Access Compliance Report

Public Rights-of-Way

(Pedestrian Signals)

Intersection ID: N/A	Main Street:	Cross Street: N/A	Location: N/A
ADA ID: FB6AD961A0C2	Signal Type: One Push Button-Non APS	Overall Compliance: No	Severity Score: BTN 1: N/A BTN 2: N/A No BTN: N/A
Codes/Mitigation Info/Possible Solution		Field Measurements/Component Compliance

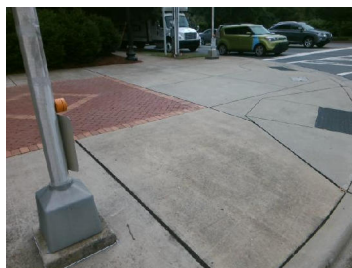
PROW/ADA: TMUTCD 4e.08, R404.2, R406.2

Compliance	Description	Data	Compliance	Description	Data
	Button Count	Button1	Yes	Distant to Additional Button (in)	461.0
	Additional Button Present?	Yes		Additional Button ID	41894E210D22
N/A	Signal Buttons Required?	N/A	N/A	Additional Ped Posts Required	N/A
	How Many Ped Street Xings?	2		Located In An Island/Median?	No
N/A	B 1 Sign Present?	Yes	N/A	B 2 Sign Present?	N/A
Yes	B 1 Sign Purpose?	Yes	N/A	B 2 Sign Purpose?	N/A
Yes	B 1 Sign Lettering & Contrast?	Yes	N/A	B 2 Sign Lettering & Contrast?	N/A
Yes	B 1 Parallel To XWalk?	Yes	N/A	B 2 Parallel To XWalk?	N/A
Yes	B 1 PAR to Button?	Yes	N/A	B 2 PAR to Button?	N/A
Yes	B 1 PAR to XWalk?	Yes	N/A	B 2 PAR to XWalk?	N/A
Yes	B 1 Clear Floor Space?	Yes	N/A	B 2 Clear Floor Space?	N/A
N/A	B 1 FWD Approach?	Yes	N/A	B 2 FWD Approach?	N/A
N/A	B 1 FWD Approach Constrained?	No	N/A	B 2 FWD Approach Constrained?	N/A
No	B 1 FWD Approach Reach (in)	4.5	N/A	B 2 FWD Approach Reach (in)	N/A

N/A	B 1 FWD Approach Width (in)	N/A	N/A	B 2 FWD Approach Width (in)	N/A
N/A	B 1 FWD Approach Obstruction?	Yes	N/A	B 2 FWD Approach Obstruction?	N/A
N/A	B 1 FWD Approach Obstruction Dist (in)	4.5	N/A	B 2 FWD Approach ObstructionDist (in)	N/A
N/A	B 1 PARA Approach?	Yes	N/A	B 2 PARA Approach?	N/A
N/A	B 1 PARA Approach Constrained?	No	N/A	B 2 PARA Approach Constrained?	N/A
Yes	B 1 PARA Approach Reach (in)	4.5	N/A	B 2 PARA Approach Reach (in)	N/A
N/A	B 1 PARA Approach Width (in)	N/A	N/A	B 2 PARA Approach Width (in)	N/A
N/A	B 1 PARA Approach Obstruction?	Yes	N/A	B 2 PARA Approach Obstruction?	N/A
N/A	B 1 PARA Approach Obstruction Dist (in)	4.5	N/A	B 2 PARA Approach ObstructionDist (in)	N/A
Yes	B 1 Clear Floor Space Slope (%)	0.7	N/A	B 2 Clear Floor Space Slope (%)	N/A
No	B 1 Clear Floor Space XSlope (%)	3.8	N/A	B 2 Clear Floor Space XSlope (%)	N/A
N/A	B 1 PAR Slope (%)	0.1	N/A	B 2 PAR Slope (%)	N/A
Yes	B 1 Height (in)	38.5	N/A	B 2 Height (in)	N/A

Possible Solutions: Replace Signal Push Button With APS Button on New Post. Remove & Relocate Sign.
